Product Change Notice (PCN)

Subject: RA2E2 group I3C function revision

Description of Change:

Improved I²C / I3C bus interface function

#1 : I²C master; Operation when writing transmission data

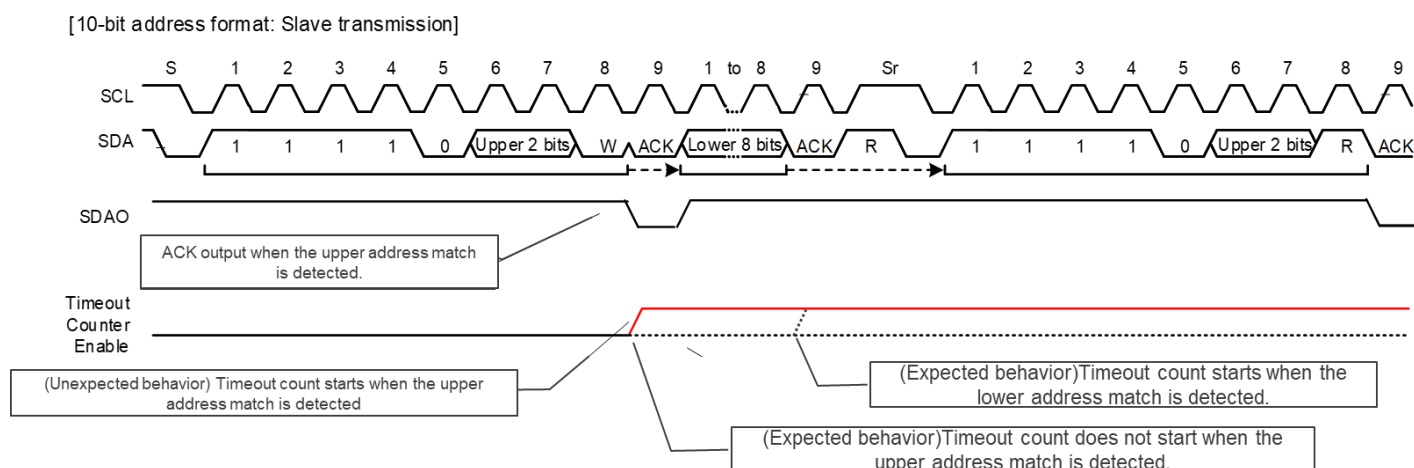
In MCU Ver.1, when the output timing of the first data of the frame and the transmission data write timing are conflicted, the transmission of the first data to be transmitted (b7) will start with a deviation of 1 bit.

MCU Ver.1 requires the software workaround when writing transmission data, but MCU Ver.2 does not require the software workaround.

Note: [MCU Ver.1 has the following restrictions and workarounds. These restrictions and workarounds are not required for MCU Ver.2.](#)

The following processing is required when checking NTST.TDBEF0 = 1 in Steps [3] and [4] of the I²C master transmission flowchart as shown in Figure 25.104.

After confirming NTST.TDBEF0 = 1, confirm that PRSTDBG.SCILV = 0 (check the status of SCL) before writing the transmission data.

- If BITCNT.BCNT = other than 0 after confirming NTST.TDBEF0 = 1, write the transmission data immediately
- If BITCNT.BCNT = 0 after confirming NTST.TDBEF0 = 1, check that BST.TENDF = 1 and PRSTDBG.SCILV = 0 (check the status of SCL) before writing the transmission data.

#3 : I²C slave; ACK output operation when 10-bit address communication and the lower address mismatch is detected

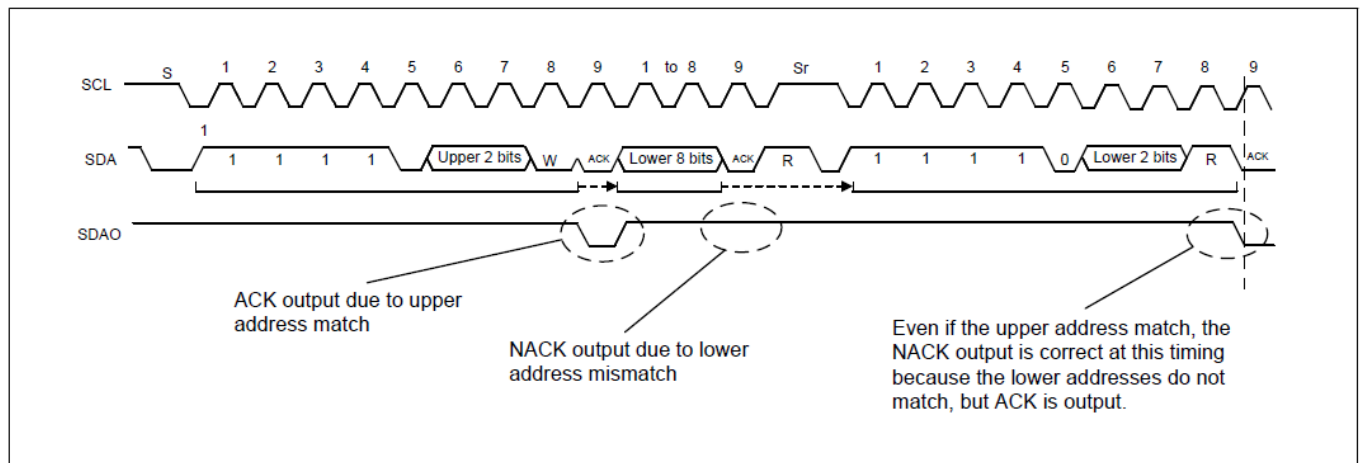
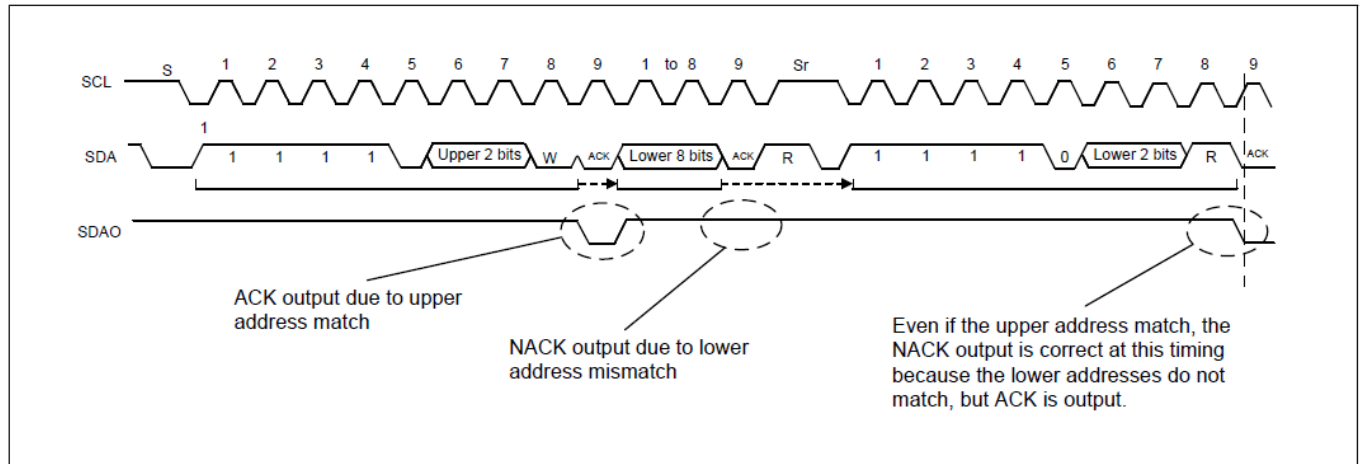
MCU Ver.1 has the following restrictions and workarounds when using 10-bit address communication. The restrictions and workarounds are not required for MCU Ver.2

When multiple I²C slaves are connected to the I²C bus and there is a possibility that an I²C Slave other than this module will NACK for the upper address / R after Repeated START, there are the following restrictions and workarounds.

- Work around : Set the upper 2 bits of the 10-bit address assigned to this module to a value different from other Slave. If the address is exhausted and cannot be set to a different value, use restriction (1).
- Restriction (1) : 10-bit address not available.
- Restriction (2) : After the ACK response in the red circle in the above figure, none of the slaves respond to data, so the SDA keeps the high level and the I²C Master receives the 0xFF data. In the case of a system that can handle 0xFF as abnormal data, 0xFF is read and discarded on the I²C Master side. If 0xFF is valid data, use restriction (1).

MCU Ver.1 has the following restrictions and workarounds. The restrictions and workarounds are not required for MCU Ver. 2.

When multiple I²C slaves are connected to the I²C bus and there is a possibility that an I²C Slave other than this module will NACK for the upper address / R after Repeated START, there are the following restrictions and workarounds.

- Work around : Set the upper 2 bits of the 10-bit address assigned to this module to a value different from other Slave. If the address is exhausted and cannot be set to a different value, use restriction (1).
- Restriction (1) : 10-bit address not available.
- Restriction (2) : After the ACK response in the red circle in the above figure, none of the slaves respond to data, so the SDA keeps the high level and the I²C Master receives the 0xFF data. In the case of a system that can handle 0xFF as abnormal data, 0xFF is read and discarded on the I²C Master side. If 0xFF is valid data, use restriction (1).

4 : I3C slave; Arbitration operation when Dynamic Address is assigned by the ENTDAAC command

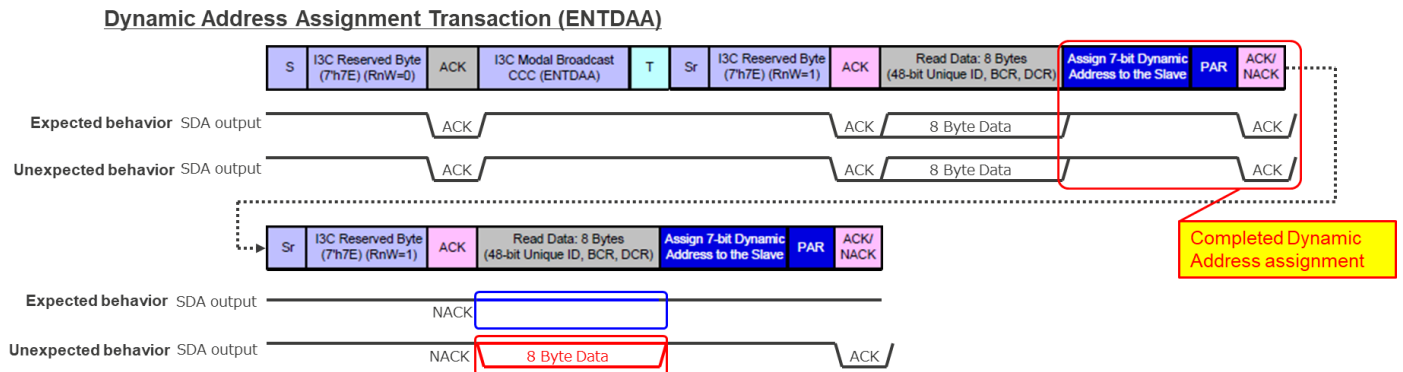
In MCU Ver.1, if a dynamic address is assigned by the ENTDAAC command in I3C slave mode, I3C will participate in dynamic address arbitration in response to the ACK response of other slaves even after the dynamic address assignment.

MCU Ver.1 requires the restrictions and workarounds when assigning dynamic address, but the restrictions and workarounds are not required for MCU Ver.2.

MCU Ver.1 has the following restriction and workaround. This restriction and workaround are not required for MCU Ver.2.

Note: When multiple I3C (I3C Slave) are connected on the I3C Bus assign Dynamic Addresses in the following order.

1. Set the SDCTPIDH and SDCTPIDL registers (6 Bytes) of the I3C (I3C Slave) to a value (All 1 etc.) that has a lower priority than other Slave Devices by Dynamic Address Arbitration.
2. After setting the Static Address in the I3C (I3C Slave), assign the Dynamic Address using the SETDASA / SETAASA command.
3. Assign a Dynamic Address to an I3C Slave Device other than the I3C (I3C Slave) using the ENTDAAC command.

Figure 25.96-1 Example of error recovery operation flowchart for I3C Master

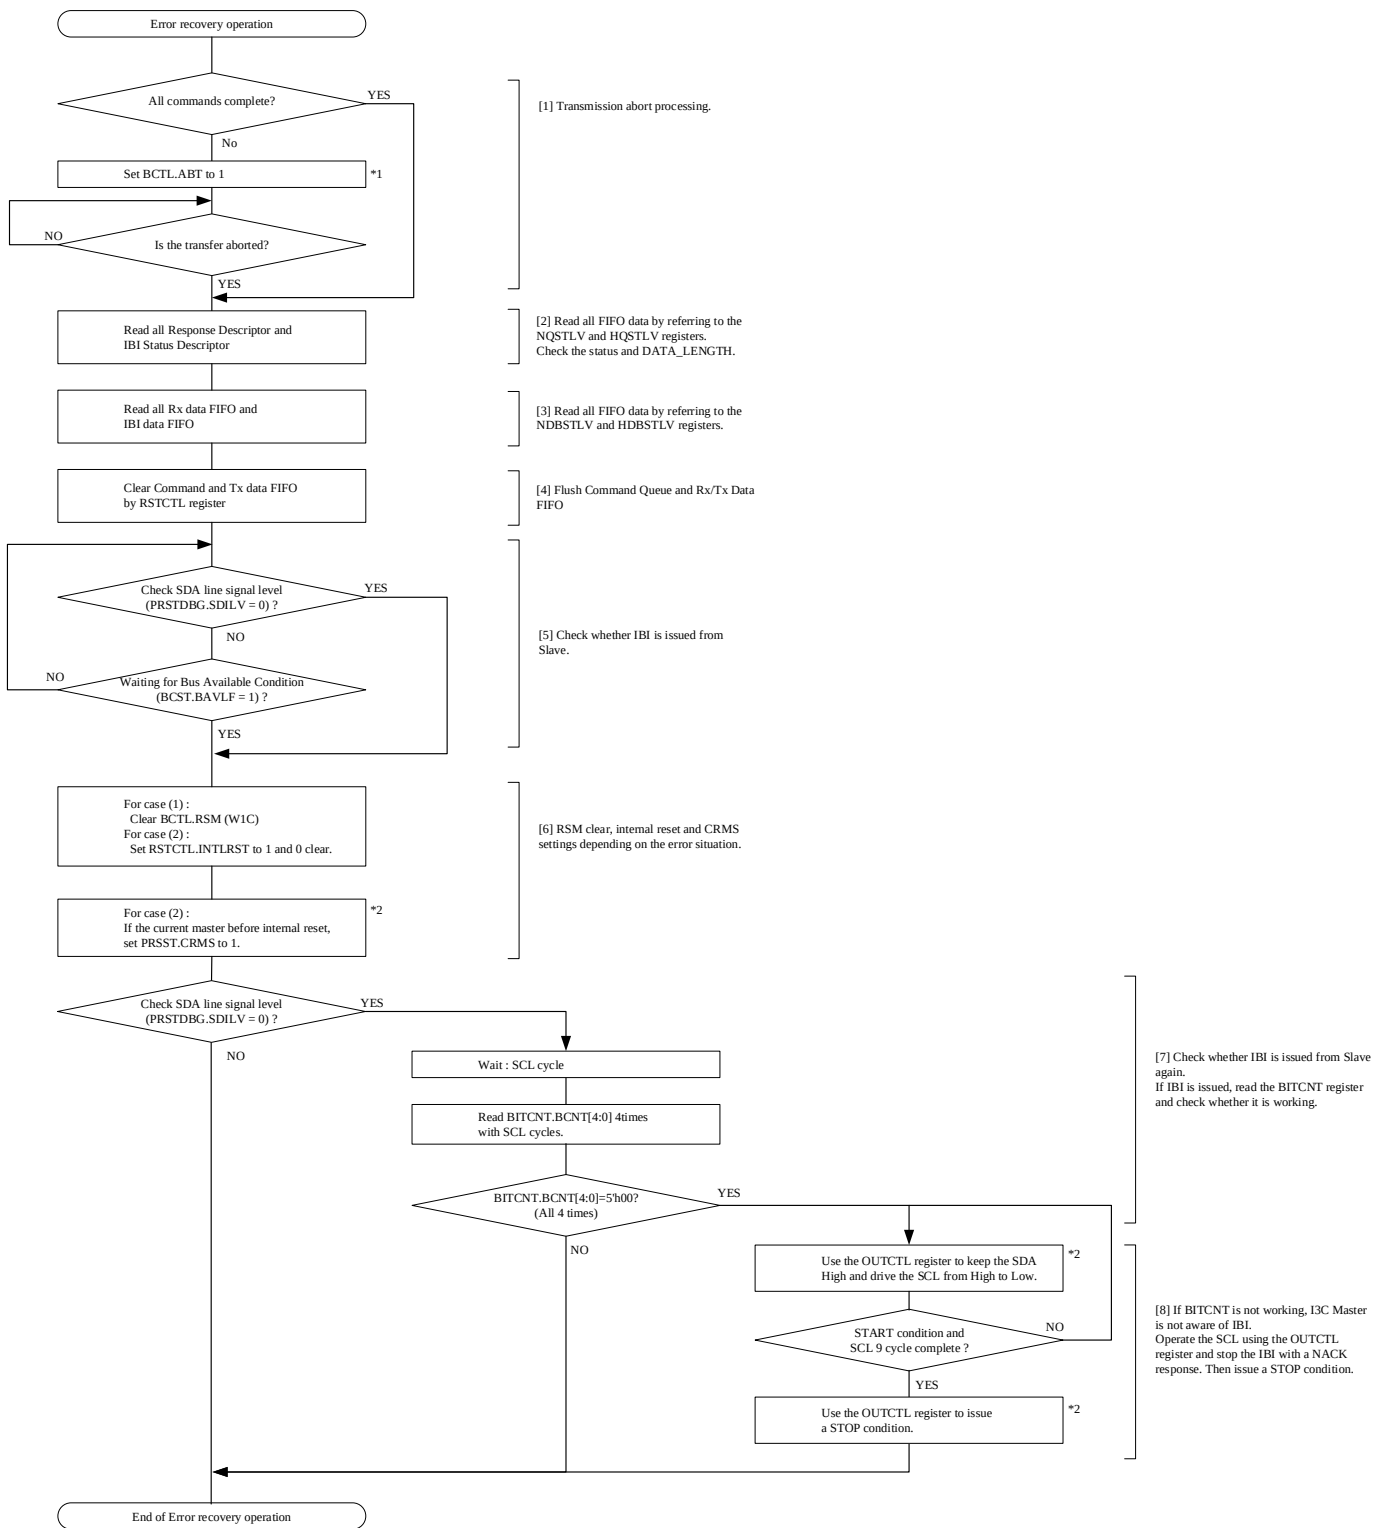
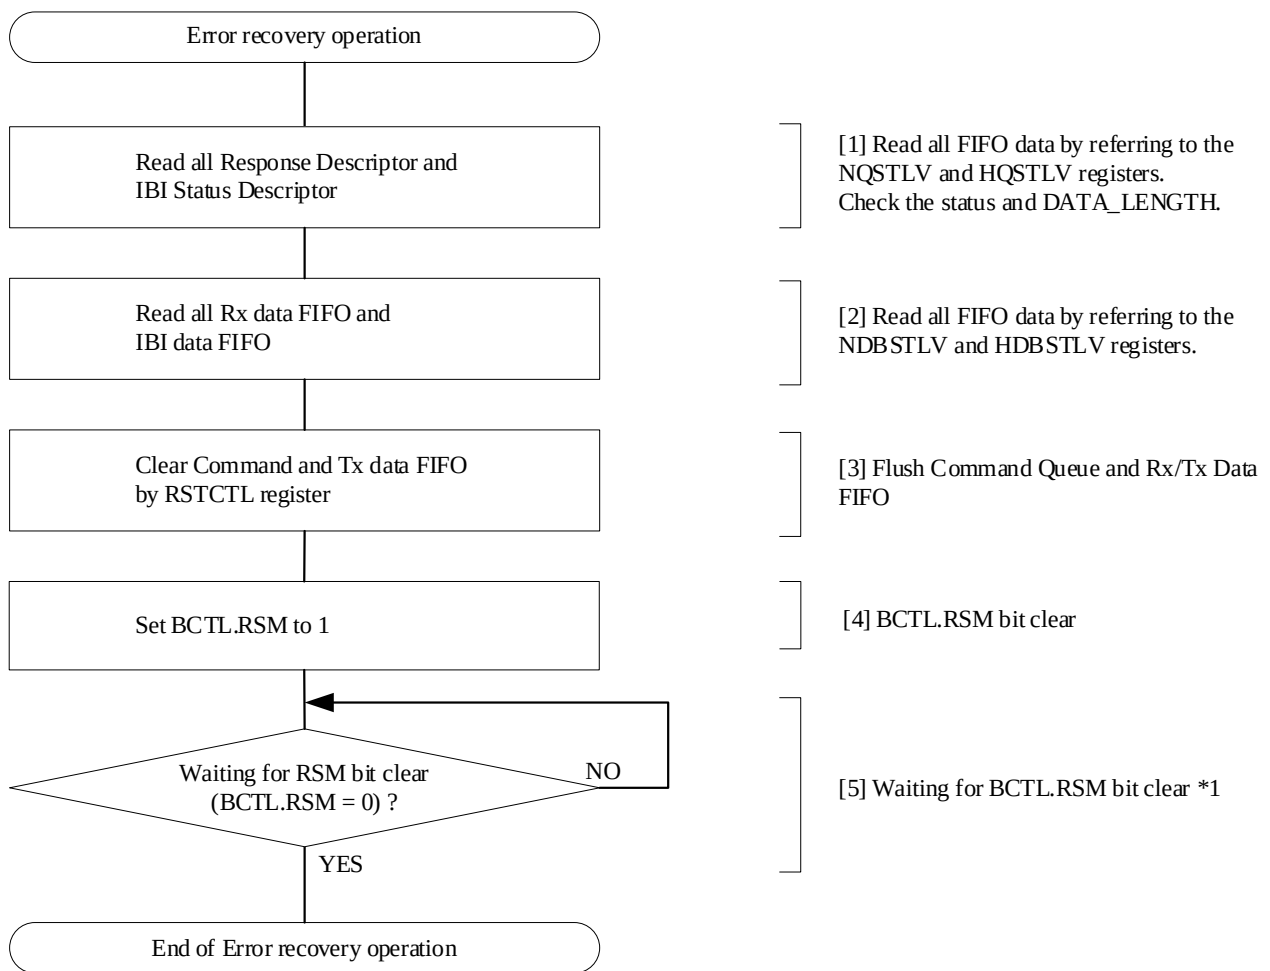
In order to improve the complexity of the error recovery flow, MCU Ver.2 is revised the circuit so that I3C will be suspended (BCTL.RSM becomes 1) when an error occurs. After I3C is suspended, the application must write the value 1 to the BCTL.RSM bit to resume I3C operation and recover from suspended state. In MCU Ver.2, the error recovery flow shown in Figures 25.96 and Figures 25.97 are simplified by the above improvements.

Figure 25.96-1 and Figure 25.97-1 show the error recovery flow of MCU Ver.1.

Note: For MCU Ver.2, apply the following error recovery flow.

If an error occurs, I3C will be suspended. (BCTL.RSM becomes 1.) After I3C is suspended, the application must write the value 1 to the BCTL.RSM bit to resume I3C operation and recover from the suspended state.

Figure 25.96-2 and Figure 25.97-2 show the error recovery flow of MCU Ver.2.

Note 1. It is possible to set the Command Descriptor while waiting for the RSM bit to be cleared.
